Access Compliance Report

Public Rights-of-Way

(Curb Ramps)

Intersection ID: 11049	Main Street: MALTA_PL	Cross Street: OAK_FOREST_DR	Location: N
ADA ID: 89810C329683	Ramp Type: ParaDiag	Initial Pass/Fail: Fail	Overall Compliance: No
			Severity Score: 26.25

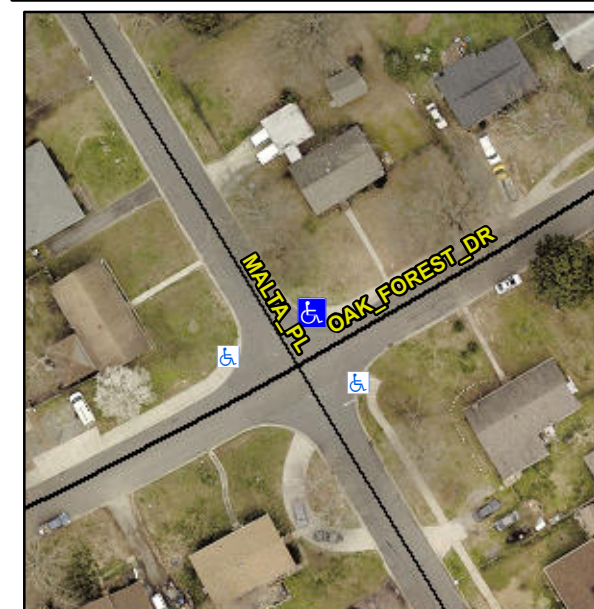
LT RP < 5%

R304.5.3, R304.3.2

Compliance	Description	Data	Compliance	Description	Data
N/A	Ramp Length LT (in)	25.5	N/A	Ramp Length RT (in)	27.0
Yes	Ramp Width LT (in)	60.0	Yes	Ramp Width RT (in)	60.0
Yes	Ramp Slope LT (%)	0.8	No	Ramp Slope RT (%)	12.3
No	Ramp XSlope LT (%)	3.4	No	Ramp XSlope RT (%)	4.2
N/A	Landing Length (in)	N/A	N/A	DWS Provided?	N/A
N/A	Landing Width (in)	N/A	N/A	DWS Contrast?	N/A
N/A	Landing Slope (%)	N/A	N/A	DWS Length (in)	N/A
N/A	Landing X Slope (%)	N/A	N/A	DWS Full Width?	N/A
N/A	Landing Curb? (Y/N)	N/A	N/A	DWS Offset (in)	N/A
N/A	Shared Landing?	N/A			
N/A	Gutter Ponding?	N/A	N/A	Gutter Slope (%)	N/A
N/A	Gutter Lip Ht (in)	N/A	N/A	Gutter X Slope (%)	N/A
N/A	Painted X Walk1?	No	N/A	Painted X Walk2?	No
	X Walk 1 Direction	To SW		X Walk 2 Direction	To SE
N/A	X Walk 1 Width (in)	N/A	N/A	X Walk 2 Width (in)	N/A
	X Walk 1 Slope (%)	1.4		X Walk 2 Slope (%)	0.3
	X Walk 1 X Slope (%)	1.3		X Walk 2 X Slope (%)	1.2
N/A	Ramp inside XWalk1?	N/A	N/A	Ramp inside XWalk2?	N/A

Remove & Replace Curb Ramp With Two New Directional Ramps or Equivalent.
